***MAJOR PROJECT ASSESSMENT:***

**Woollooware Bay Town Centre – Retail / Club Precinct**

**MP 10\_0230**

Director-General's  
Environmental Assessment Report  
Section 75I of the  
*Environmental Planning and Assessment Act 1979*

**Figure 8:** Areas of protrusion from approved Building Envelope (Source: Proponent's additional information to PPR / RtS)

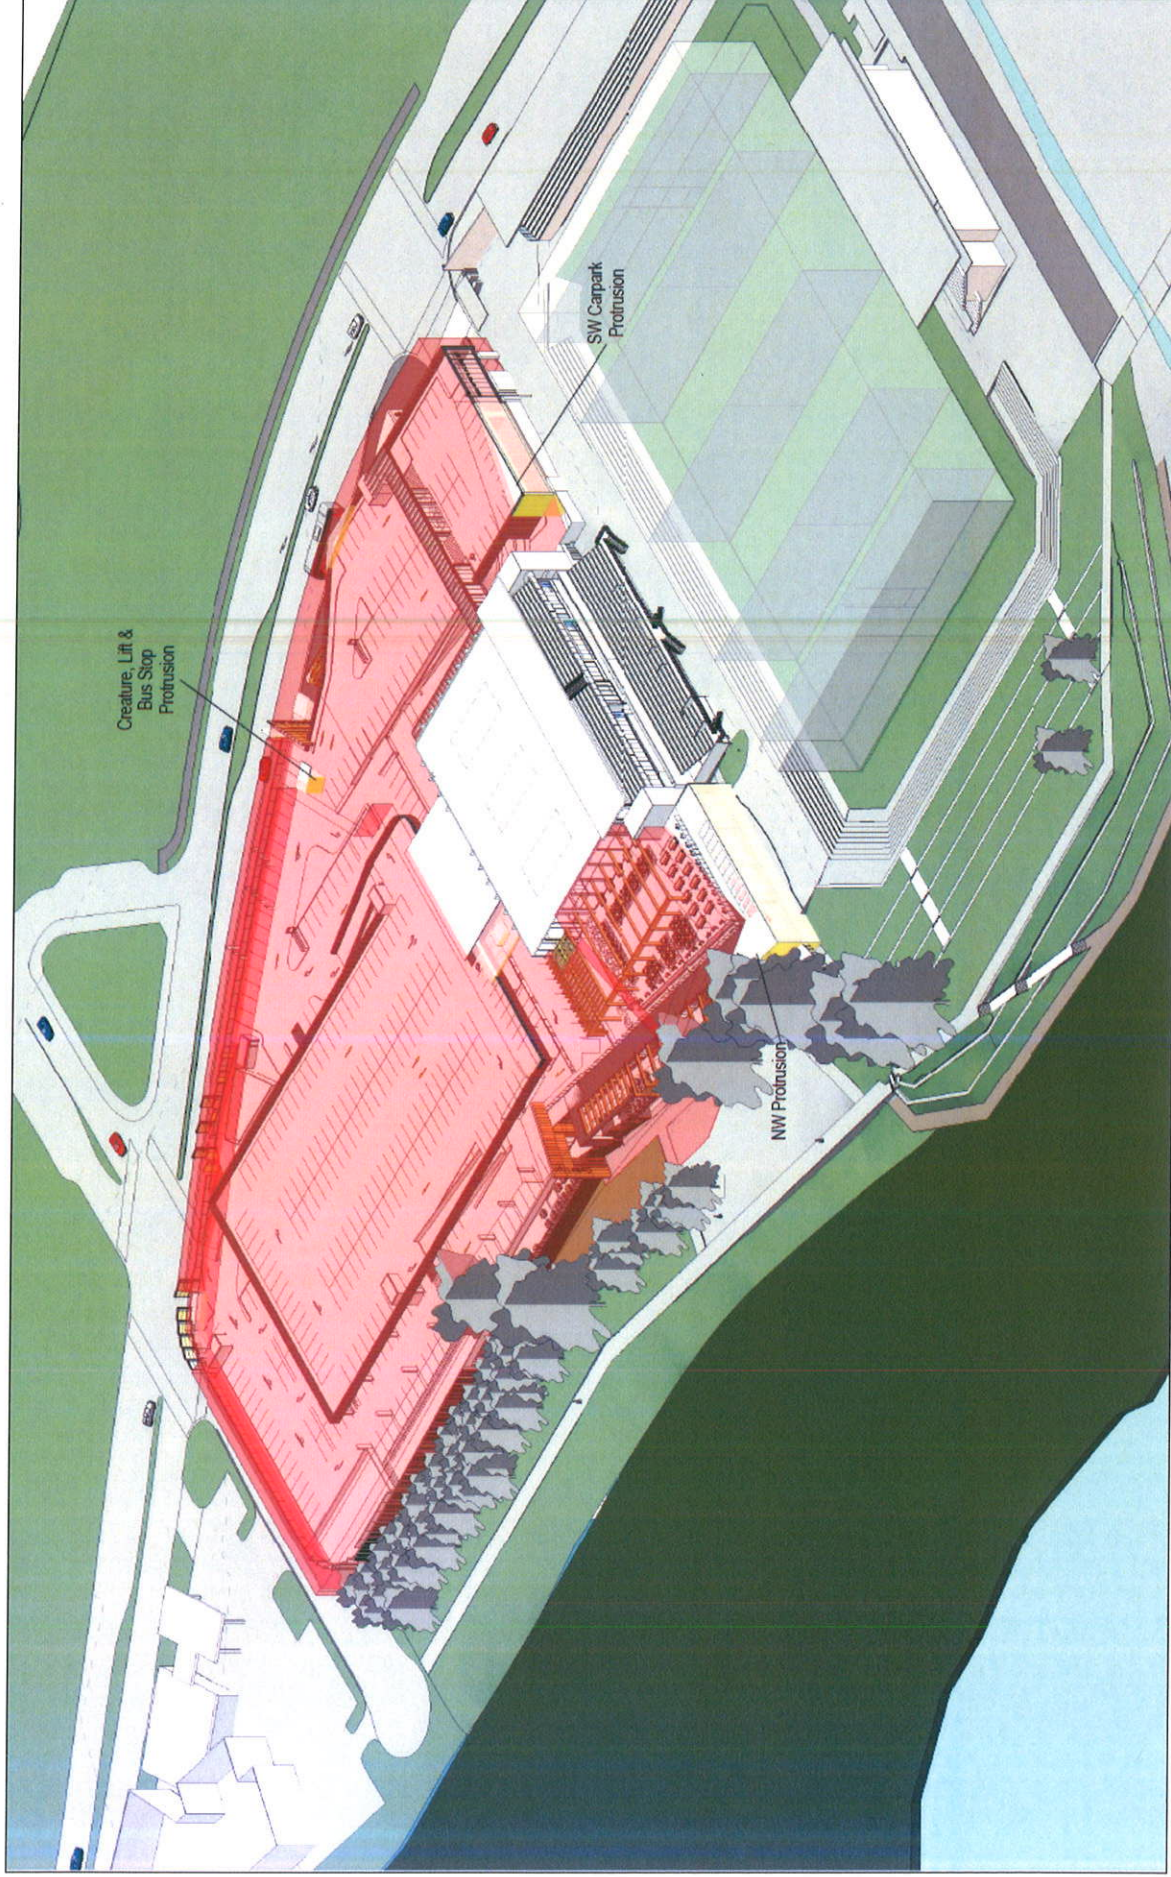
Overall, the proposal is also considered to generally comply with the building envelope approved under the Concept Plan. It is noted however that 27 protrusions are proposed in 4 general areas being the Leagues Club and Retail Centre entrance, Captain Cook Drive frontage and building corner to Woollooware Road / Captain Cook Drive intersection, Leagues Club deck roof and the leisure centre and Level 2 dining areas (**Figure 8**).

The Department notes that the majority of the variations are minor building articulation protrusions (less than 1 metre), which will have a no material impacts. Two elements of the proposed building that are more substantial are the northwest (leisure centre, restaurant and retail areas) and southwest (car park extension) protrusions. These elements are largely as a result of detailed design modifications. In this regard, the Department provides the following comments on these two elements:

The Department raises no objections to the variations proposed.

Figure 12: Proposed riparian buffer corridor to the north of the retail centre (Source: Proponent's PPR / RfS)

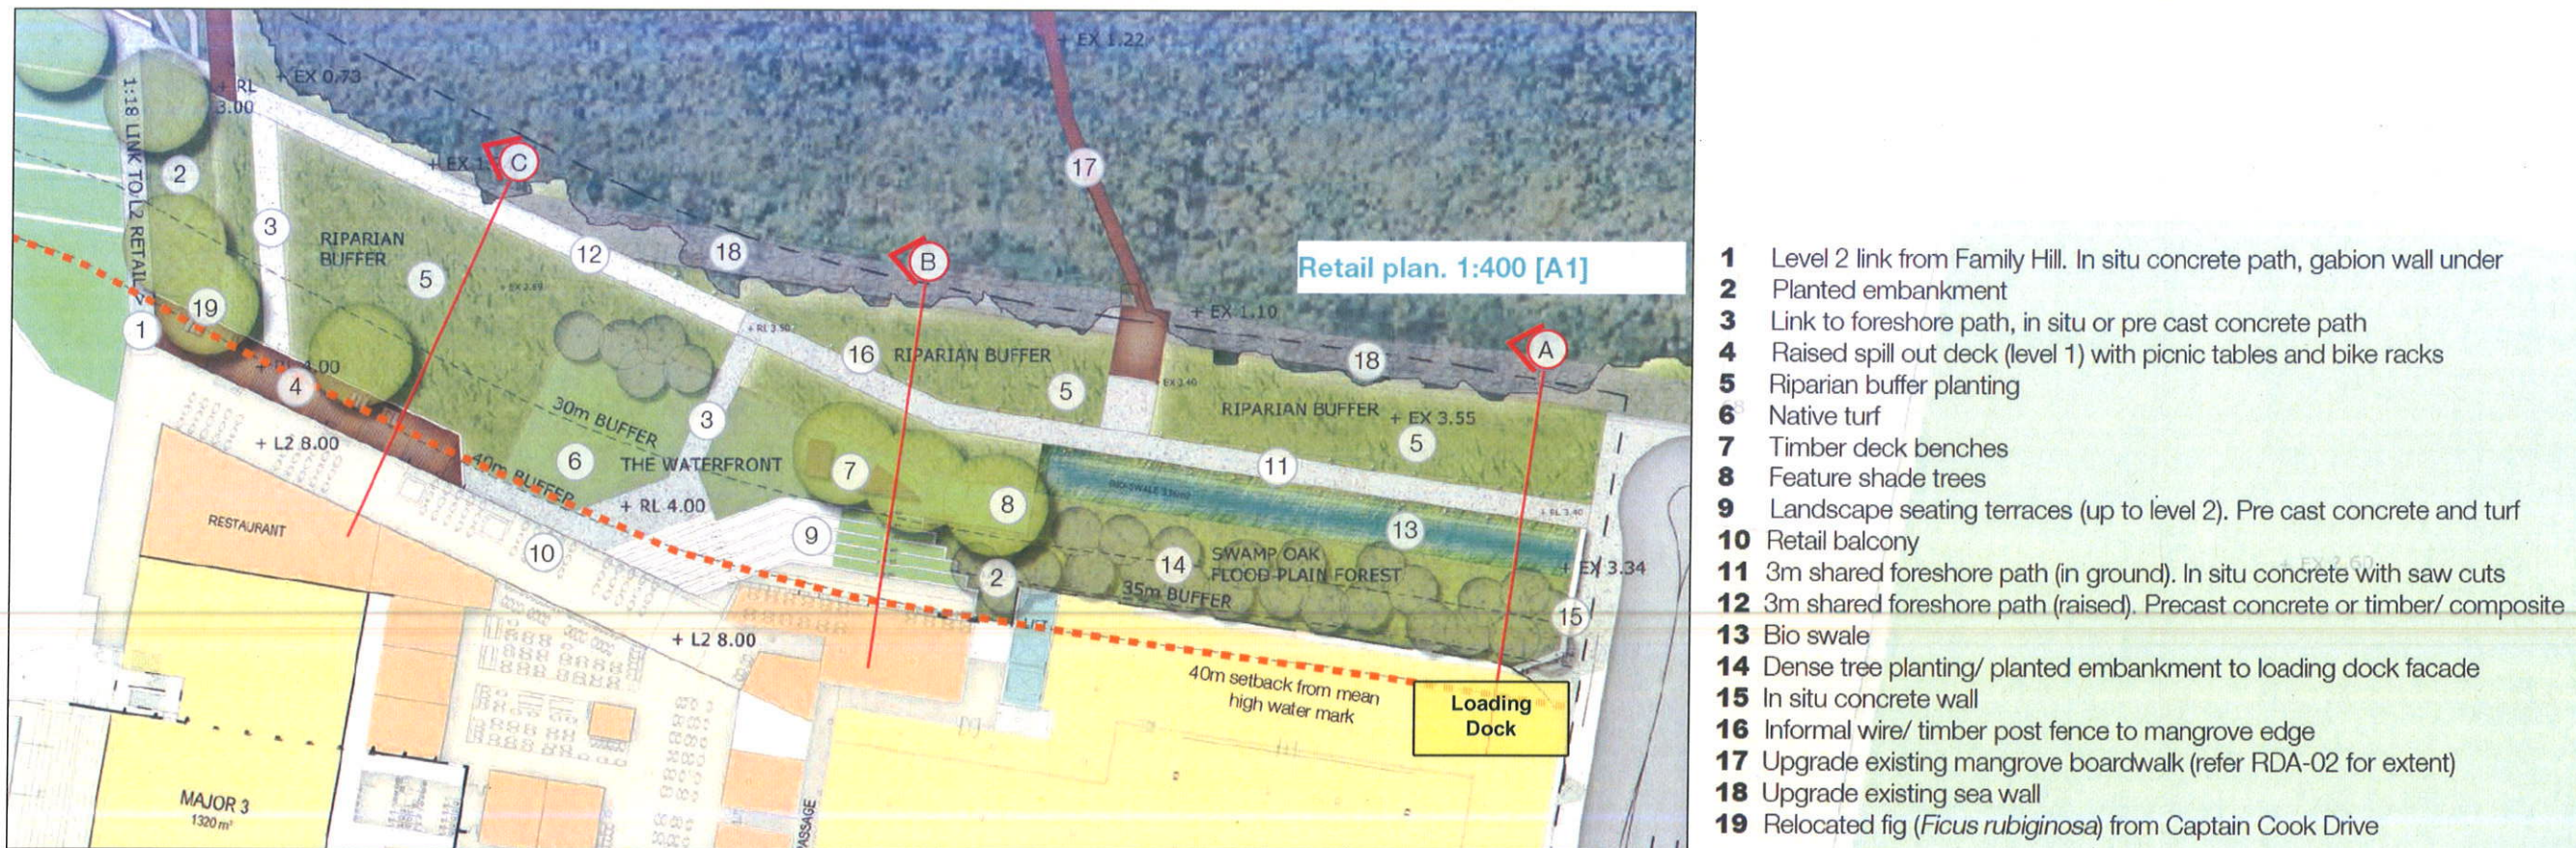
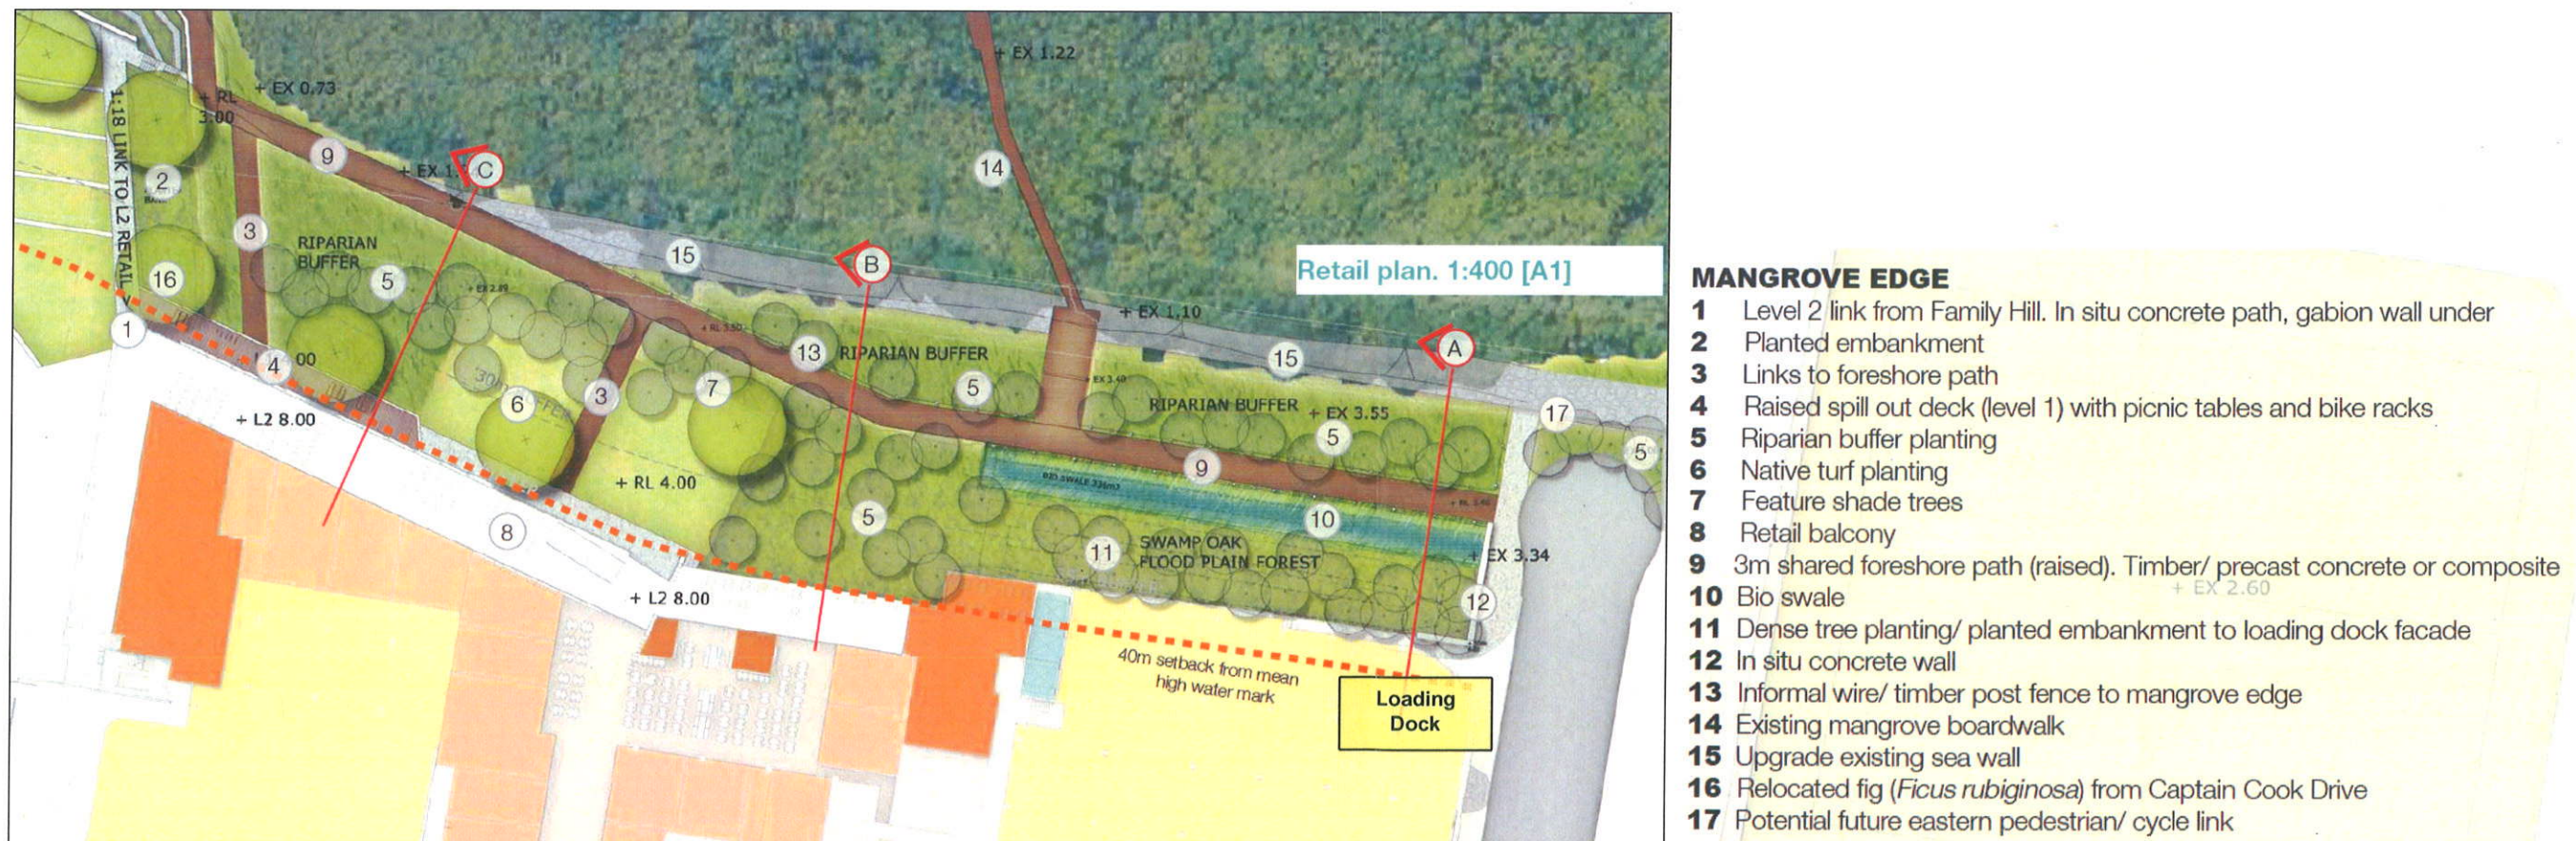
The exhibited EA included structures such as landscaped terraces and seating areas within the corridor. These structures were included to create a passive recreation area linking with the pedestrian / cycle pathway along the foreshore (**Figure 11**).

The PPR provides an amendment to the design of the riparian setback area (**Figure 12**) through the deletion of the landscaped seating terraces and timber deck benches, raising of the path to be a suspended structure and provision of additional landscaping (cross sections of the riparian area are provided in **Figures 9 and 10**). Landscaping proposed in this buffer area has been selected to be consistent with a desired riparian functionality and character of the foreshore setback, with the inclusion of native turf planting consistent with recent foreshore upgrades by Council.

Noting the above guideline and planning circular, the Department is of the view that this area provides an important link between the foreshore and the retail building. The planting of vegetation suitable to the locality, while recognising the expected future pedestrian use of the area to access the stadium or to continue walking / cycling along the foreshore area to the east and west of the site, is a key factor in the functionality of this area. This is considered to meet the DPI guidelines and planning circular.

**Figure 13: Woollooware Road North extension illustrating additional land used compared to existing car parking area (Source: Proponent's PPR / RtS)**

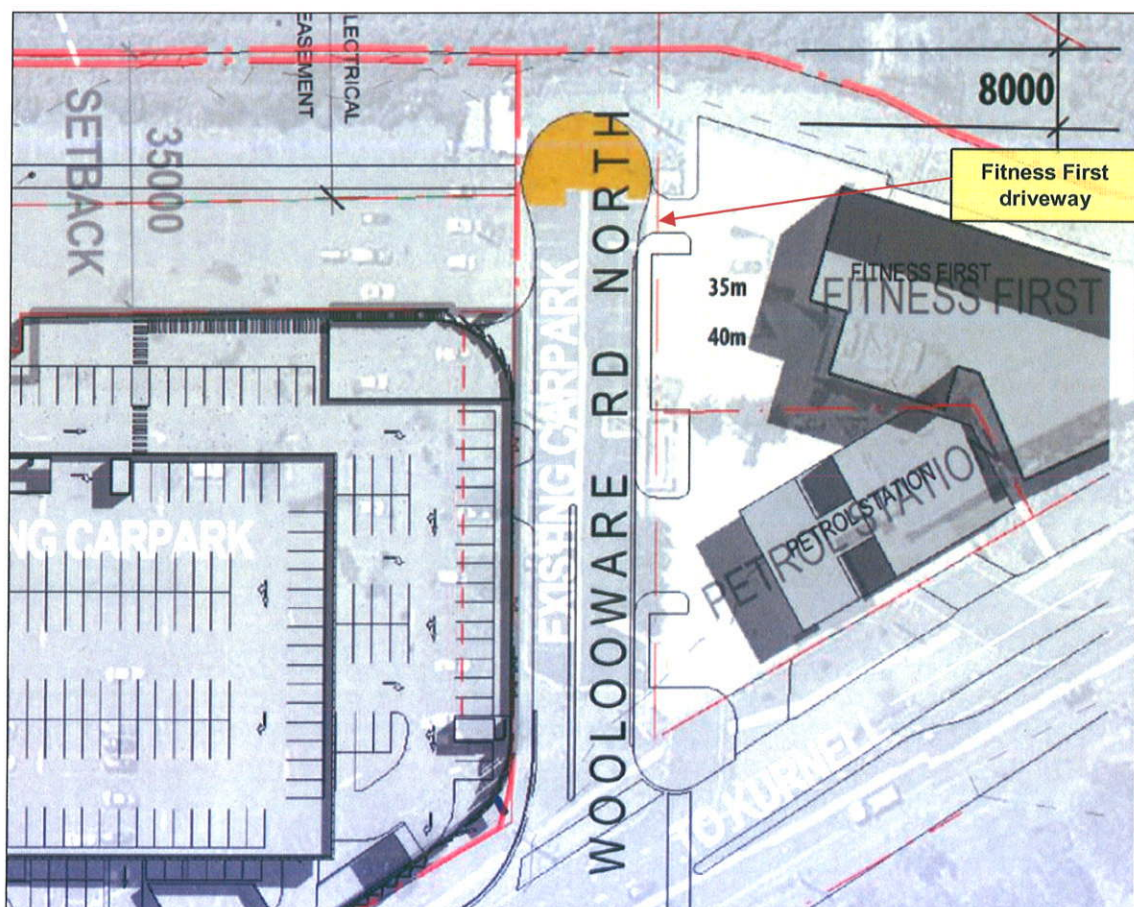
In its consideration of the Concept Plan, the Planning Assessment Commission noted that the turning bay will need to be carefully designed and considered at the development application stage, to minimise, and if possible avoid, any intrusion into the 40 metre foreshore setback zone.

The PPR has increased this setback from 5 metres to 8 metres by reducing the length of Woollooware Road North. While the length of the proposed roadway extends the existing car parking area (shaded orange in **Figure 13**), the Department is of the view that the 8 metre setback will assist in enabling future revegetation of this area or the use by Council as a continuation of a footpath / cyclepath to join onto Captain Cook Drive. The extended roadway will comprise of similar kerb and guttering enabling stormwater to be collected prior to discharge into Woollooware Bay. It is also noted that the cul-de-sac is designed within the Council's road reserve and the proposed 8 metre setback is consistent with the adjoining setback provided between the foreshore and adjoining Fitness First building.

Noting the above, the Department does not raise concerns with the proposed setback of 8 metres to Woollooware Bay.

Figure 14: Loading dock servicing the retail centre (Source: Proponent's PPR / RtS)

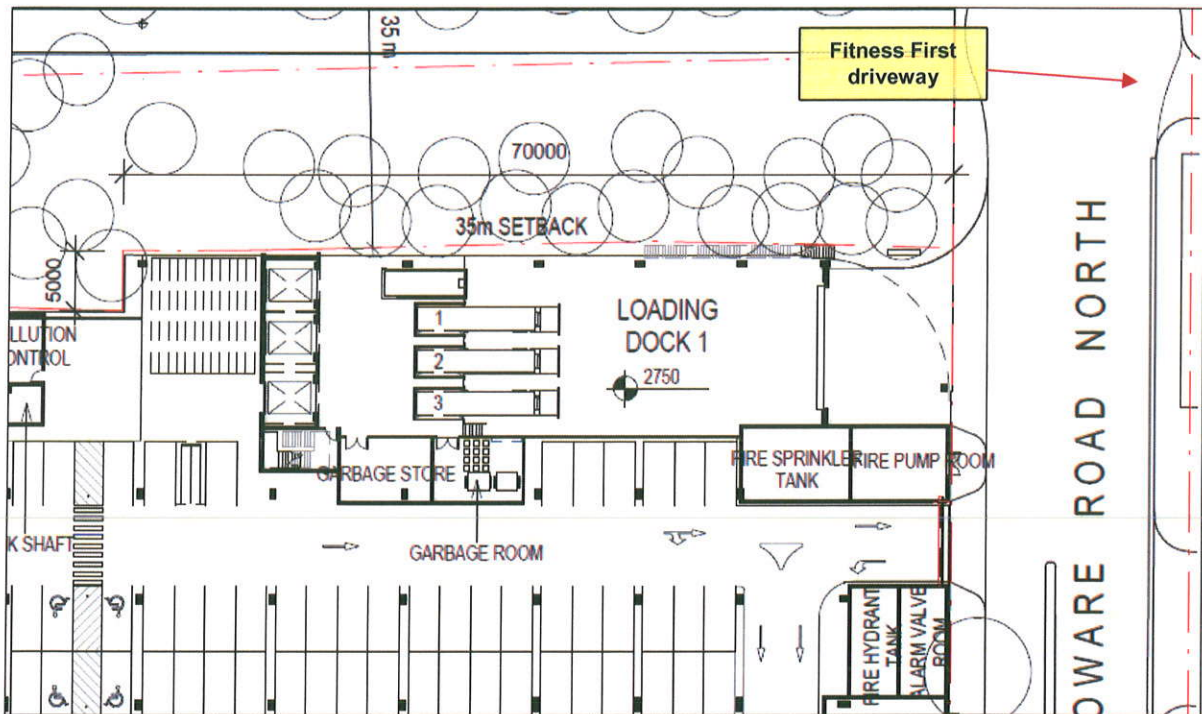
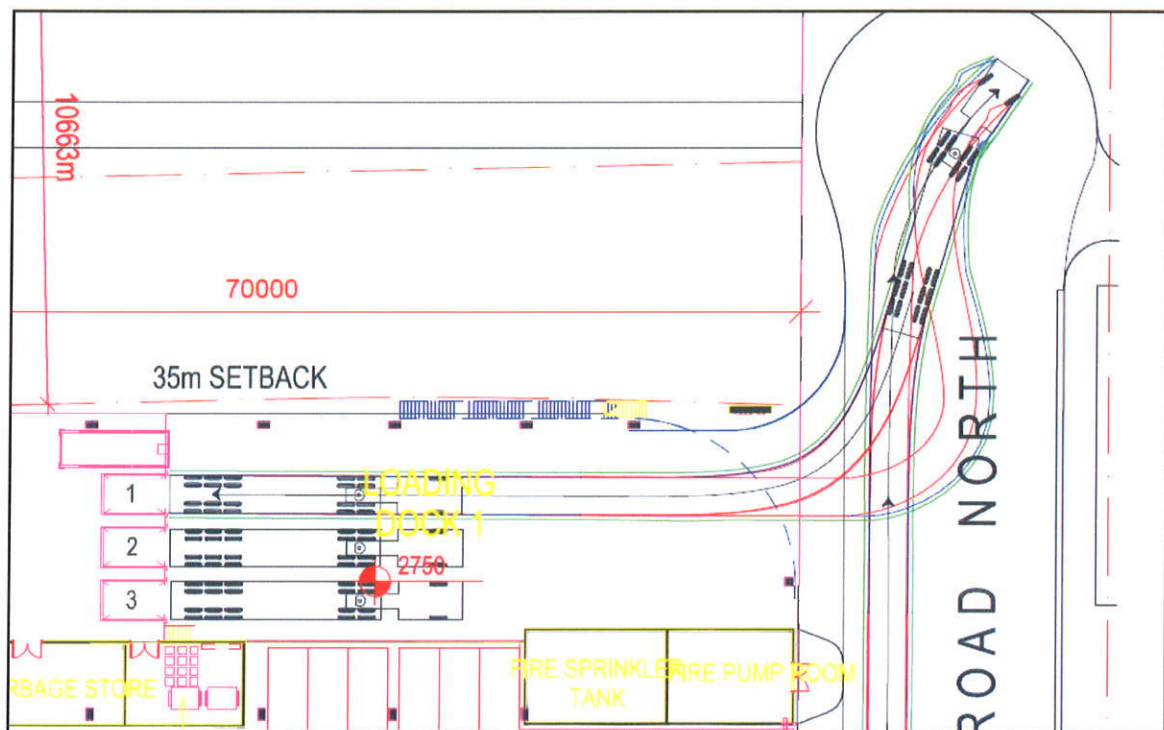
Council raised concerns with the location of the Club loading dock area and sought modifications to improve pedestrian movement across the Captain Cook Drive frontage. The Department has also reviewed the width of the retail loading dock and its operation and provides comments below.

The narrow design of the retail loading dock has resulted in delivery vehicles needing to reverse into the loading dock off Woollooware Road North (**Figure 15**), rather than enter in a forward direction and manoeuvre within the loading dock as originally proposed within the Concept Plan EA. The Department acknowledges that the length of Woollooware Road North has also been

designed to enable delivery vehicles to manoeuvre into and out of the loading dock area, while maintaining access to the Fitness First building on the opposite side of Woollooware Road North (Figure 14).

The Department supports the introduction of this plan as its implementation will manage potential conflict between delivery vehicles and car park uses. Times of operation of the loading dock to ensure that delivery vehicles are predominantly contained outside peak shopping times will be a key factor to be addressed. Condition No. F13 is therefore recommended requesting that the Loading Dock Management Plan be prepared and submitted to the Director-General for approval prior to the first occupation certificate being issued.
